RANDALL COMMERCIAL PARK SUBDIVISION,

REVISED PLAT

APPLICATION NUMBER 21 DATE August 18, 2005
APPLICANT Randall Commercial Park Subdivision, Revised Plat
REQUEST Subdivision

DETAIL SITE PLAN

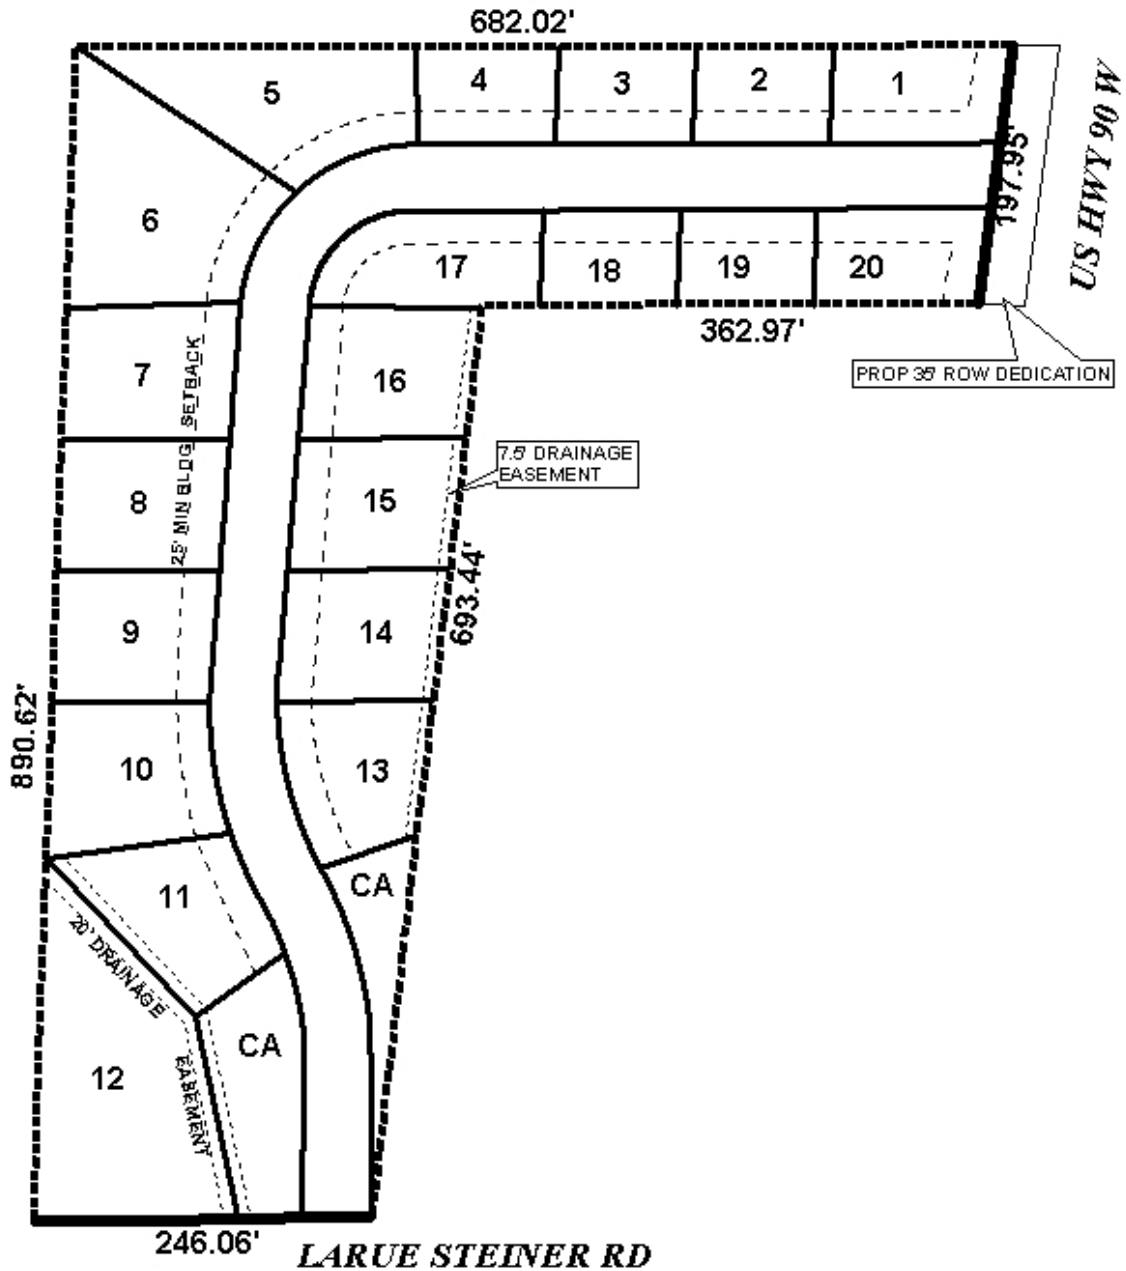
The site fronts Larue Steiner Road, which has an 80-foot right-of-way, and U.S. Highway 90, which has a varying right-of-way, which appears to be 180-feet in this vicinity. U.S. Highway 90 is illustrated on the Major Street Plan with a proposed 250-foot right-of-way; as such, dedication of sufficient right-of-way to provide 125-feet from the centerline of the highway would be required, and would be satisfied by the 35-foot dedication shown on the plat.

As the subdivision involves the creation of a new street, construction and dedication of the street to County Engineering standards would be required. Dedication of 25-foot radii at the intersections with U.S. Highway 90 and Larue Steiner Road should also be required; and a temporary turnaround at the North end of the new street should be required until such time as the new street connects to the highway. The placement of a note on the final plat stating that proposed Lots 1 and 20 are denied direct access to U.S. Highway 90 should also be required.

The plat depicts two detention/common areas; thus, a note should be required on the final plat stating that maintenance of these areas will be the responsibility of the property owners.

The site is located in the County; thus any lots that are developed commercially and adjoin residentially developed property must provide a buffer, in compliance with Section V.A.7 of the Subdivision Regulations.

The plat meets the minimum requirements of the Subdivision Regulations, and is recommended for Tentative Approval, subject to the following conditions: 1) the construction and dedication of the new street to County Engineering standards; 2) the dedication of 25-foot radii at the intersections with U.S. Highway 90 and Larue Steiner Road; 3) the construction of a temporary turnaround at the North end of the new street, until the street connects to U.S. Highway 90; 4) the placement of a note on the final plat stating that Lots 1 and 20 are denied direct access to U.S. Highway 90; 5) the placement of a note on the final plat stating that maintenance of detention/common areas will be the responsibility of the property owners; and 6) the placement of a note on the final plat stating that any lots that are developed commercially and adjoin residentially developed property must provide a buffer, in compliance with Section V.A.7 of the Subdivision Regulations.
